# UNITED STATES PATENT AND TRADEMARK OFFICE

APPLICATION NO.	FILING DATE	FIRST NAMED INVENTOR	ATTORNEY DOCKET NO.	CONFIRMATION NO.
10/579,328	05/15/2006	Stephane Revol	290905US6X PCT	2136
22850	7590	08/13/2008		
OBLON, SPIVAK, MCCLELLAND MAIER & NEUSTADT, P.C. 1940 DUKE STREET ALEXANDRIA, VA 22314			EXAMINER MALEKZADEH, SEYED MASOUD	
			ART UNIT	PAPER NUMBER
			1791	
			NOTIFICATION DATE	DELIVERY MODE
			08/13/2008	ELECTRONIC

<b>Office Action Summary</b>	<b>Application No.</b> 10/579,328	<b>Applicant(s)</b> REVOL, STEPHANE	
	<b>Examiner</b> SEYED M. MALEKZADEH	<b>Art Unit</b> 1791

FIG. 4A

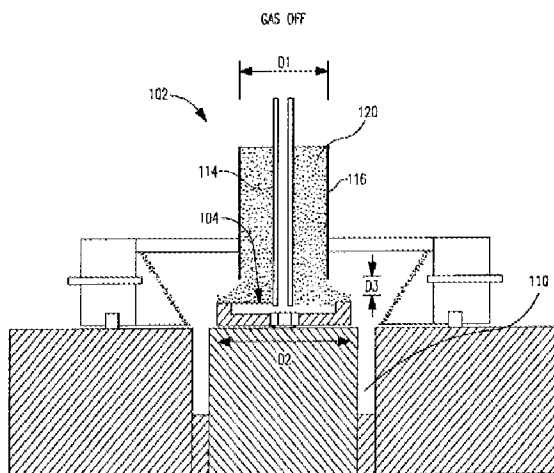
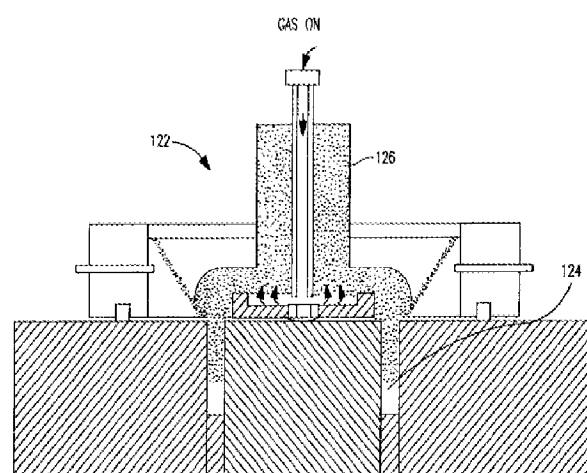
Zahrah et al (US '500) teach a delivery and filling system for filling a mould cavity (124) with a particulate material such as powder wherein the system comprises a mini-hopper (10) and collimator (126) as a means for adding at least one powder including a power inlet and a powder outlet in which the mini-hopper (10) has the same structural functionality as a

receptacle, an individualized fluidizer (114) as an introducing pipe with an entrance orifice, a porous distributor plate (104) as a means for ejecting the powder added into the device, and a bowl section positioned above the mold cavity (124) as a deflector in which locally intercept and redirect part of the powder ejected from the ejector means towards the mould cavity (124). (See lines 11-67, column 15 and figures 4A - 4B)

Zahrah et al (US '500) further teach the delivery chute (122) is centered above the die cavity (124) by pushing and moving the fill-shoe. (See lines 52-61, column 15) Therefore, the prior art teaches the deflector is mobile and orient-able.

Moreover, Zahrah et al (US '500) disclose the means (126) for adding powder includes a powder inlet and a powder outlet, and further the deflector is a part of an internal wall of the ejecting device.

The prior art, thus, meets all the claim limitations and therefore Zahrah et al (US '500) anticipate the claims 16-18, 26, and 29-30.

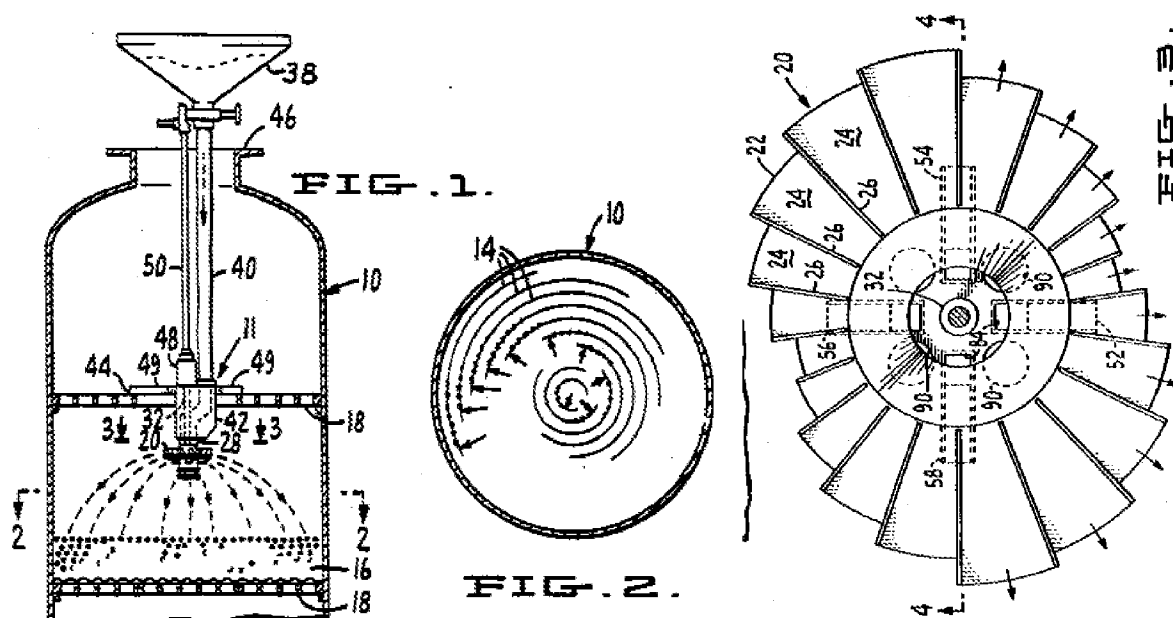
also teach a mean for ejecting the powder includes a tray as a lower part, a collimator (126) as an upper part and an entrance orifice (114) and a powder outlet. However, Zahrah et al. ('500) fail to teach rotating the ejecting means for ejecting powder as a rotating device which is in a shape of a disk, a cone, or a bowl, and includes at least one rib, as claimed in claims 19-21.

In the analogous art, Souers et al. (US '202) teach an apparatus for simultaneously distributing particles across the full diameter of particles across the full diameter of the bed with a single rotor wherein the apparatus comprises a large diameter catalytic reactor vessel (10), a hopper (38), a supply tube (40), a catalyst loading apparatus (11), a lower feed hopper (42), a feed tube (28), and a catalyst distribution rotor member (20) as a disk-like rotating device in which the disk-like rotating device (20) comprises a plurality of sectors or segments (24) with rib members (26), a drive shaft (32) for the rotation of the rotor member (20), (See column 7 and lines 12-50, column 8; further, figures 1 and 3) wherein the particles are distributed by the single disk-like member across the full diameter of the bed with substantially uniformly high density through forming a multiplicity of annular rings of the powder concentric with the center of the vessel or bed. (See lines 62-68, column 4)

Therefore, it would have been obvious for one of ordinary skill in the art at the time of applicant's invention to modify the device for the powder filling of the mold as taught by Zahrah et al. ('500) through providing a disk-like rotating device with ribs as an ejection mean for the filling of the mold in order to uniformly distribute the powders within the mold cavity in such a way that the powders have a high density, as suggested by Souers et al. (US '202)

FIG. 2

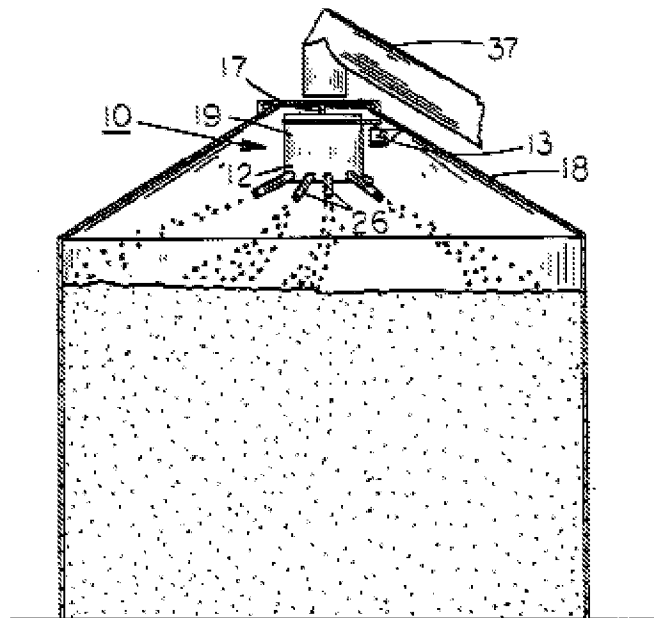
In the analogous art, Olson et al. (US '613) teach a particle spreading apparatus as a powder spreading apparatus for dispersing particles in which the apparatus includes grain storage bin (18), a grain conveyor (37), a distributing apparatus (10) comprising a rotating shaft (17), a grain holding unit (12), a cylindrically shaped drum (19), and an output tube (26), wherein the particles holding unit may be selectively rotated about the mounting unit by appropriately controlling the motor in order to evenly distribute the particles throughout the particle storage bin. (See lines 60-68, column 2 and lines 1-20, column 3; figures 2-3)

Therefore, it would have been obvious for one of ordinary skill in the art at the time of applicants' invention to modify the device for powder filling of the mold as taught by combined teachings of Zahrah et al. ('500) and Souers et al. ('202) through providing a curved tube for the rotating device of the ejection apparatus for distributing the powder within the mould cavity in order to effectively control the distribution of the powders through the mold cavity and also to fill the mould cavity with even layers of powder, as suggested Olson et al. (US '613)

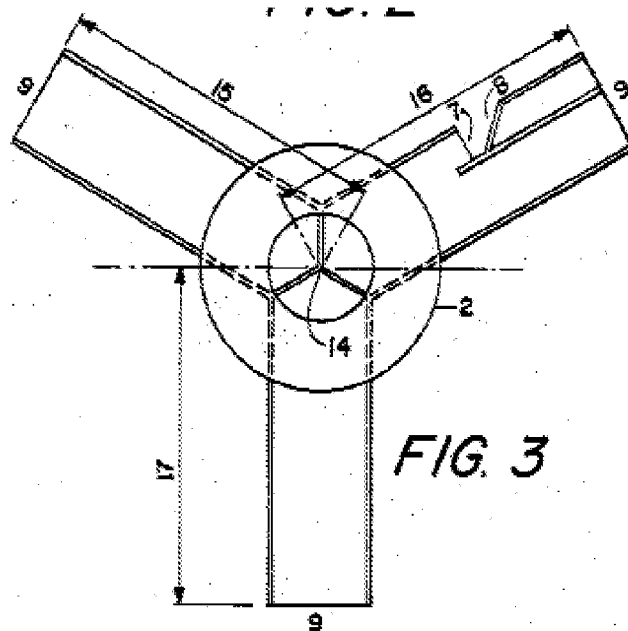
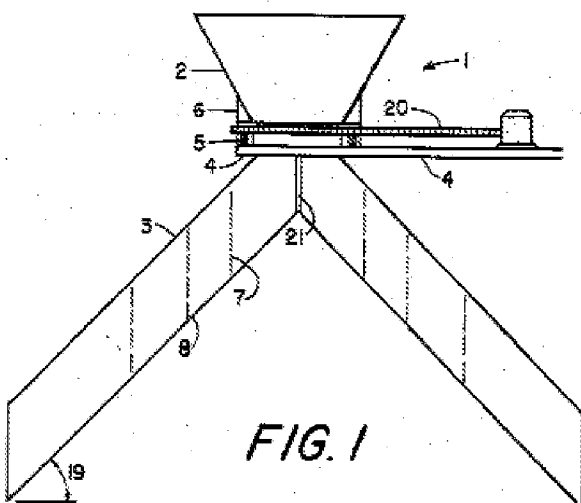
In the analogous art, Bottoms (US '887) teach a rotary distributor apparatus (1) with inclined conduits stream dividers and multiple discharge ports comprising a receiving mean (2), an optional dust shield (6), a conventional bearing (5), a fixed support (4), distributing conduits (3), drive means (20) which rotates the receiving mean (2), and dividers (7 and 21) as deflectors, wherein the powder material can be uniformly distributed in a

vessel by amount and by particle size radially from the axis of rotation at each level in the vessel, (See lines 15-22, column 1) and, further, the dividers (7 and 21) as deflectors divide a stream of particulate material passing downwardly through the conduit (See lines 39-47, column 1) in which the deflectors (7 and 21) are in parallel with the rotation axis of receiving means (2) and also the deflectors (7 and 21) are in perpendicular position relative to the plane in which the fixed support (4) is positioned. (See figures 1 and 3)

Therefore, it would have been obvious for one of ordinary skill in the art at the time of applicants' invention to modify the device for powder filling of the mold as taught by Zahrah et al. ('500) through positioning a plurality of deflectors in parallel with the rotation axis of the ejecting device in such a way that the deflectors are placed in a perpendicular direction to the median

ejection plane in order to efficiently and effectively divide a stream of the powders passing downwardly to different parts and also to uniformly distribute the powders within the mould cavity, as suggested by Bottoms et al. (US 3,780,887)
